Notice of Revised Administrative Decision (following Remand)

RE: Permit Number: 22-02629
Project Name: Arborwood Critical Area Buffer Reduction
Type of Application: Critical Area Buffer Reduction (CABR, Type I)

REVISED STAFF REPORT FOLLOWING HEARING EXAMINER REMAND

Project Name: Arborwood Critical Area Buffer Reduction

Revised Buffer Mitigation Plan (Exhibit 11, Fig 4)

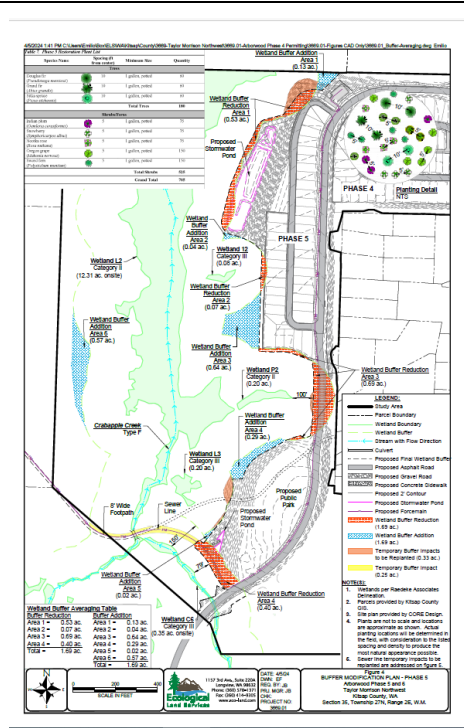
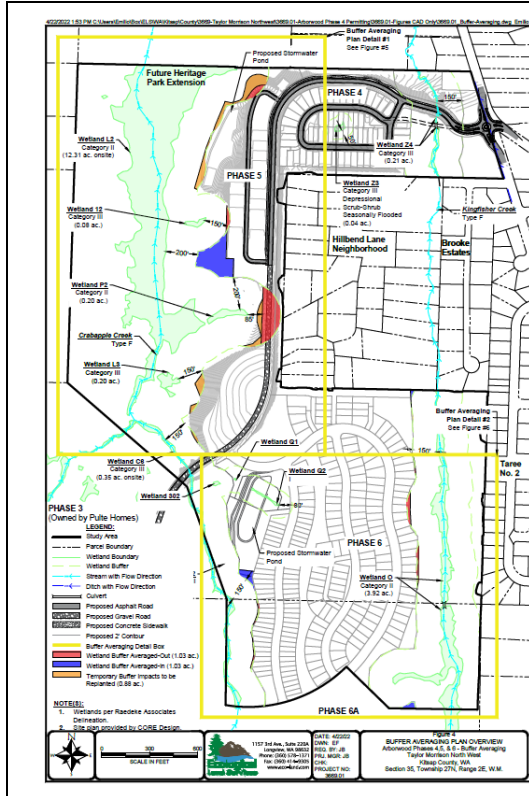
The image on the page below shows the proposed buffer averaging and reduction plans. **Staff has included the revised wetland buffer mitigation plan from ELS (from Exhibit 11)** Please see the associated Wetland Buffer Mitigation Plan by Ecological Land Services, Inc. (Dated September 2022, exhibit 3) for details. Please also find the revised Wetland Buffer Mitigation Plan by Ecological Land Services and the revised site plan. **Per the remand order (Pursuant to Conclusion of Law 50, the Decision directs staff to modify the CABR to include a new condition of approval requiring buffer averaging not resulting in buffer widths of less than 100-feet for Wetland P2), the site plan provided by Ecological Land Services, dated April 3, 2024 (provided in the second submittal as Exhibit 11), is presented here as the corrected Critical Area site plan of record. The plan shows the 100-foot buffer for wetland P-2, including an additional 17-feet of setback proposed by the applicant in excess of the code requirement referenced in KCC 19.200.220. F (building or impervious Surface Setback Lines, per the associated vested Critical Area Ordinance. The associated North Spine Road "A" Extension site plan (Exhibit 10) is the revised site plan of record.**

The plan shows the 100-foot averaged buffer for L2/P2 and proposed additional 17 feet

Revised Site Plan (exhibit 10)

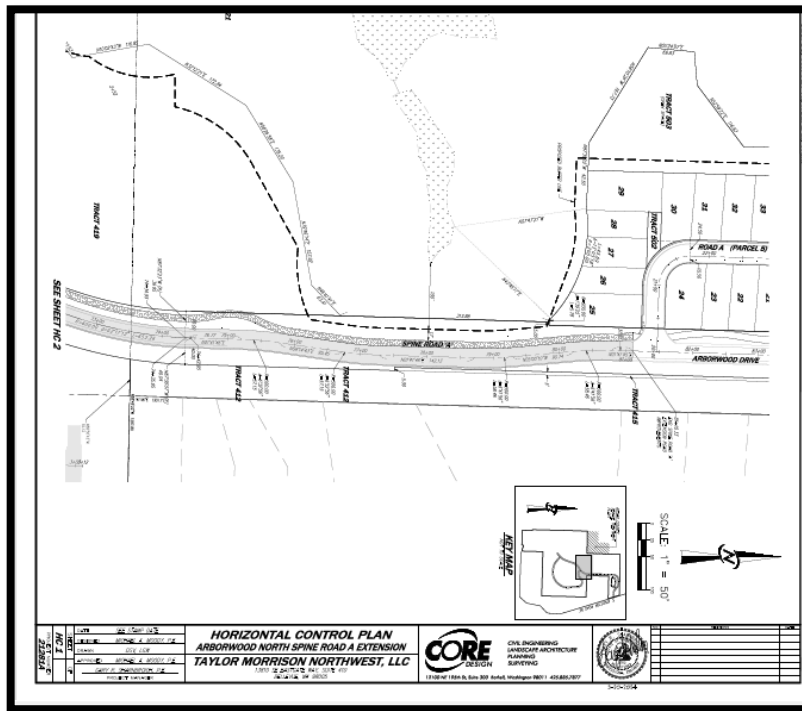
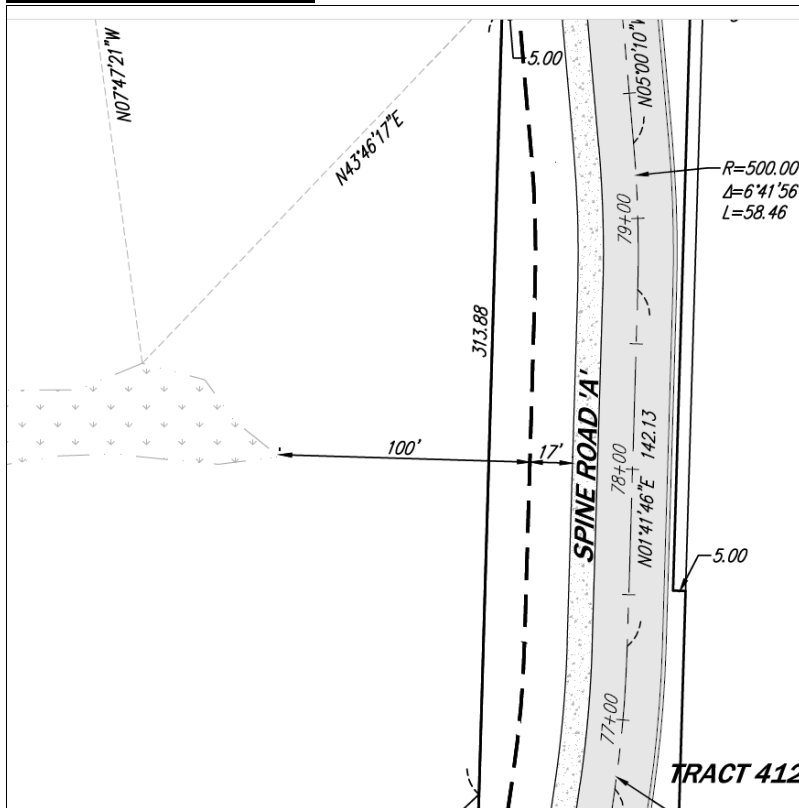
The Spine Road and adjacent pedestrian walkway has been relocated 117-feet east of Wetland P2 which is outside the 100-foot buffer. The Wetland P2 buffer has been reduced through use of buffer averaging as described in the September 2022 Wetland Mitigation Plan. Relocation of the Spine Road results in buffer averaging for Wetland P2 in compliance with the Proposed Condition imposed by the Hearing Examiner. The Proposed Condition requires that buffer averaging for the Wetland P2 buffer will not result in buffer widths of less than 100 feet pursuant to KCC 19.200.220. C.1.a.(5) (“The minimum buffer width will not be less than 50 percent of the widths established after the categorization is done and any buffer adjustments applied.”). Additionally, the relocation of the Spine Road and adjacent pedestrian walkway includes a 15-foot setback from the edge of the Wetland P2 buffer per KCC 19.200.220.F. This 15-foot setback is in addition to the 100-foot buffer as required by the Proposed Condition and KCC 19.200.220.C.1.a.(5). As noted above, the relocation of the Spine Road and adjacent pedestrian walkway is 117-feet east of Wetland P2 buffer and fully satisfies the Proposed Condition and KCC 19.200.220.F. While the construction of Spine Road A within the buffer of Wetland P2 was previously addressed using buffer averaging of the KCC 19.200.220.C.1.a., see September 2022 Wetland Buffer Mitigation Plan (5&6), the construction of Spine Road A could also have been permitted within the buffer under KCC 19.200.225.D. Section 19.200.225.D allows construction of roadways within a wetland or buffer when there are no alternatives, it serves more than one purpose, and is the minimum to provide safe roads. Even if TMN had not applied for the use of buffer reduction through buffer averaging in the previous CABR application, the location of Spine Road A in the standard buffer of Wetland P2 also meets each of the criteria as set forth in KCC 19.200.225.D, which is addressed below:
